CITY OF CEDARBURG
A MEETING OF THE SITE AND ARCHITECTURAL REVIEW BOARD
TUESDAY, OCTOBER 21, 2025 – 8:30 AM

**CITY OF CEDARBURG
SITE AND ARCHITECTURAL REVIEW BOARD
September 23, 2025**

PLANNERS REPORT

ONSITE CIVIL ENGINEERING INFRASTRUCTURE PLANS FOR CEDARBURG INDUSTRIAL

SITE DIMENSIONAL & PAVING PLAN

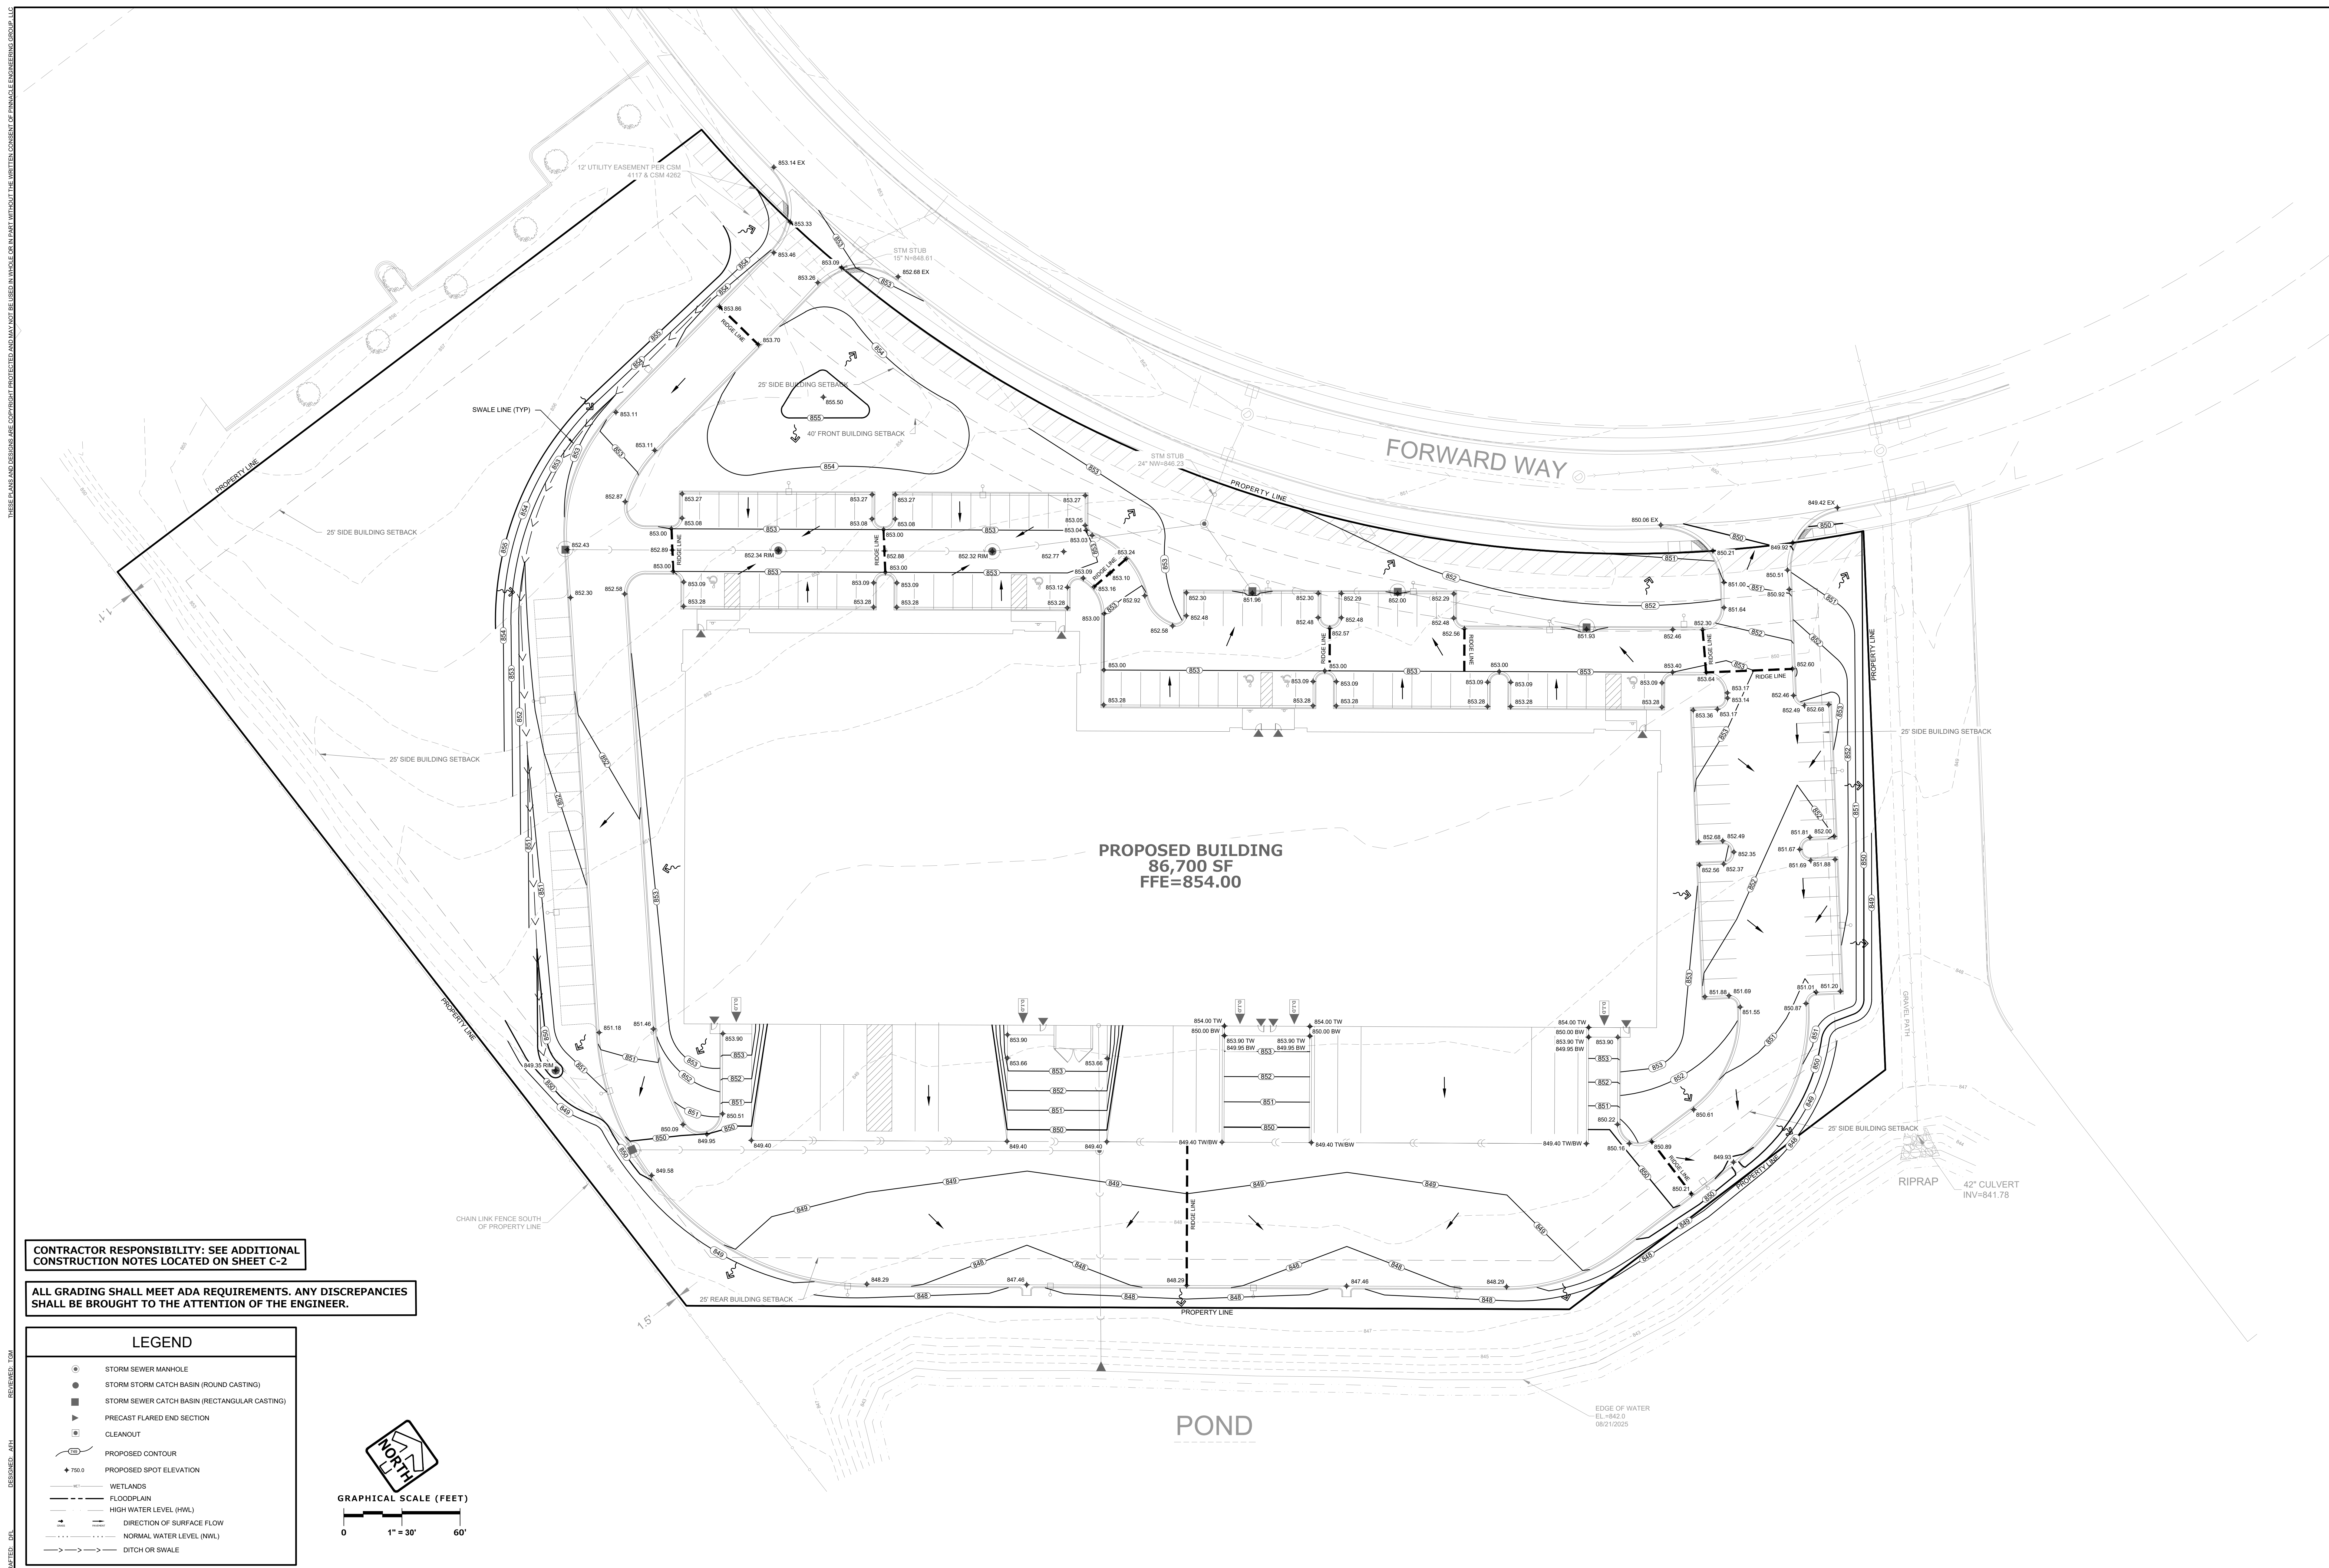
- Parking stall sizes, at 10’w x 18’d are Code compliant.
 - The loading dock and truck traffic center of this plan faces a residential development to the south. Purpose statement for M-3 provides, among other things, that “Uses in the M-3 District are also intended to provide ample off-street parking and loading areas, and landscaped planting screens in those areas adjacent to or abutting residential or other non-commercial uses, to prevent adverse effects upon the adjoining areas”.

- Eight parking stalls violate the required 25-foot parking setback.
 - Buildings shall be designed by an architect or engineer. All sides, elevations or facades of all buildings and structures shall be visually pleasing and architecturally and aesthetically compatible with the surrounding environment, as determined by the Plan Commission. Building materials shall be selected for their ability to present a visual statement of a building's purpose, attractiveness and permanence. The building materials used shall be harmonious with the general character of other buildings and structures on the property.

- The location of fire protection controls and features will be placed in locations approved by the fire department
 - Additional fire hydrants should be placed around the building – Plans indicate one hydrant by the West entrance to the property, which require a +750’ hose lay to reach the SE corner of the building

- 1) Applicant to provide compliant area calculations for:
 - a. Parking area landscaping not less than 5%.
 - b. Use of metal siding material not to exceed 25%
- 2) Applicant to provide a suitable dumpster enclosure plan (size, materials, colors, door details,...) for review and approval by the Plan Commission.
- 3) The eight parking stalls that violate the 25-foot front setback requirement must be removed from the plan.
- 4) The rear loading dock and extensive paved circulation area shall not be used as a parking lot (with the exception of vehicles temporarily backed-up to dock doors).
- 5) Outside storage of materials equipment and supplies at this site is neither proposed nor permitted at this time.

- 6) Applicant to install a buffer planting area, consisting of large deciduous canopy trees (such as Autumn Blaze Maple, White Oak, Quaking Aspen,... for instance) to screen the view to the south and southeast sides of the building from the adjoining residential neighborhood Stone Lake. These trees should be planted at not less than 2” caliper at chest height at planting, and on 60 centers. Additional large coniferous trees should be added/intermixed among these deciduous trees. Quantity to be determined by the Plan Commission.

4 SOUTHWEST ELEVATION
 SCALE: 1" = 20'-0"

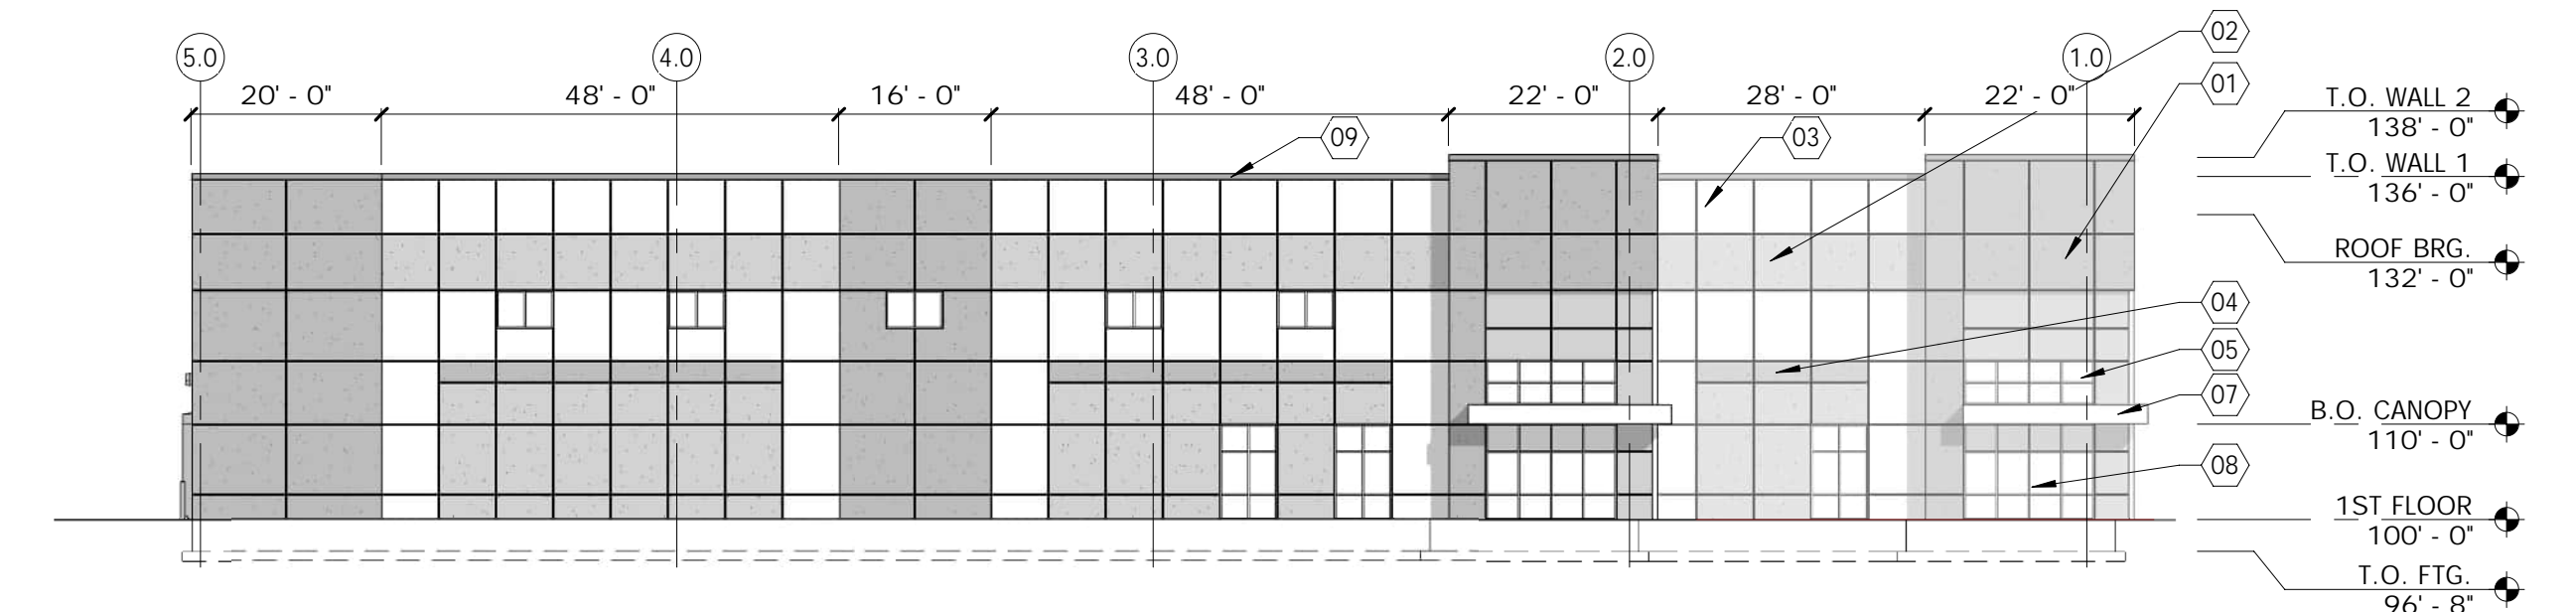
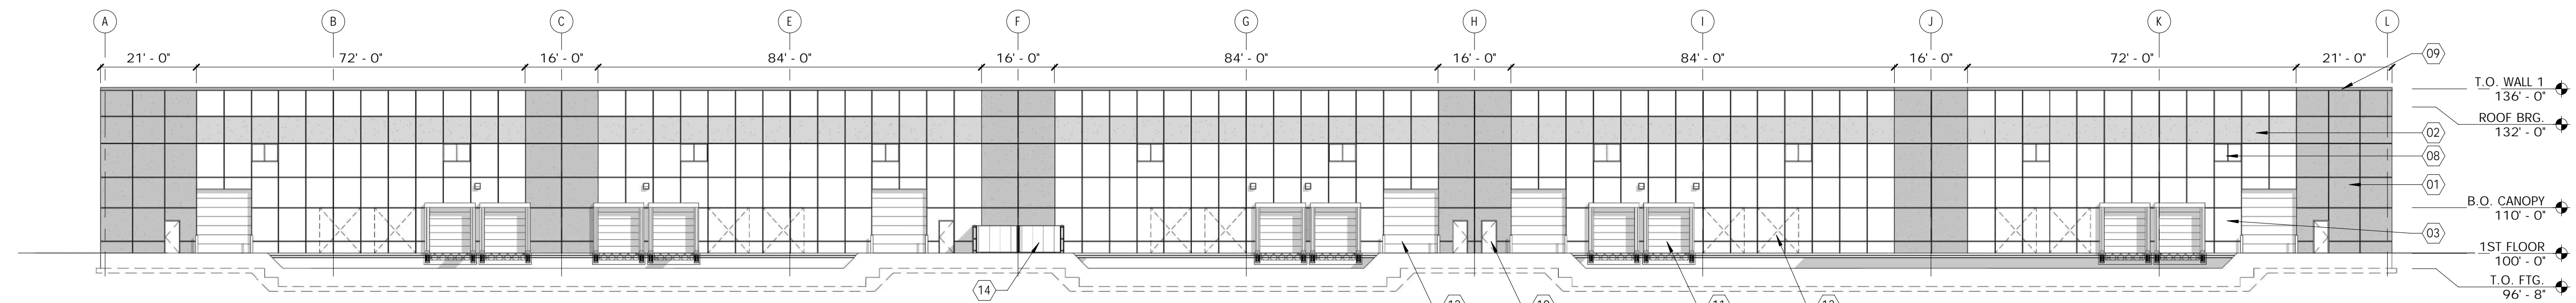
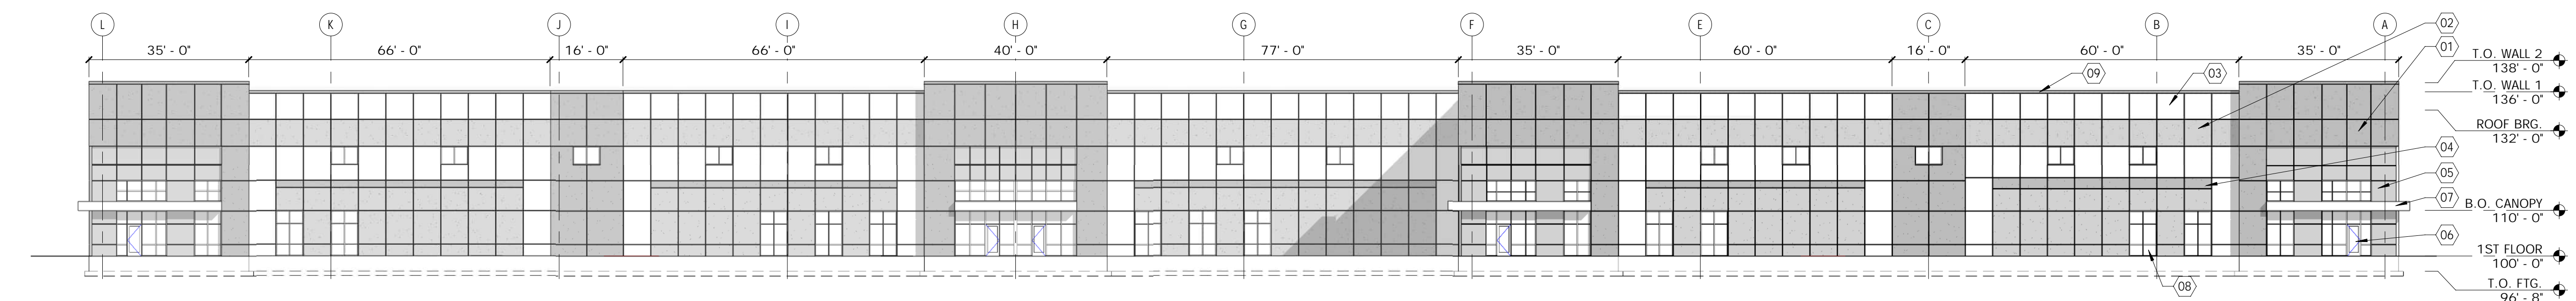
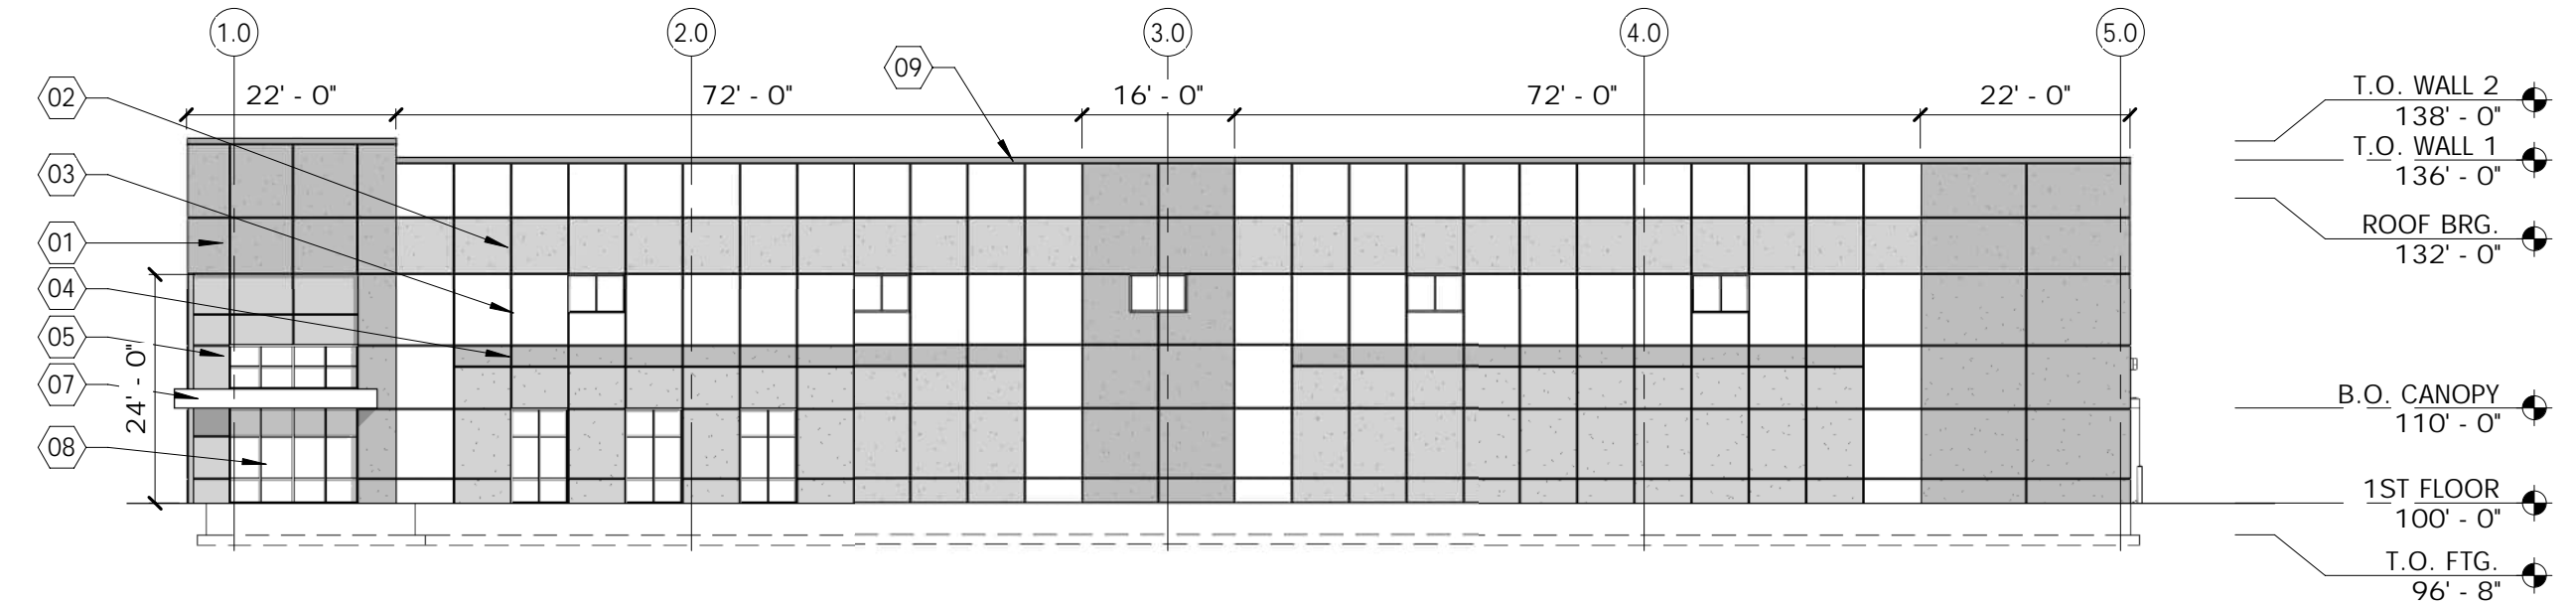
Metal siding shall be used only as a minor building component not to exceed twenty-five percent (25%) of exterior wall surface, excluding roofing, in combination with one of the above materials unless there is Plan Commission approval to exceed this amount. The metal panels must be attractive, durable, of an earth tone or compatible color and not merely an inexpensive method of building.
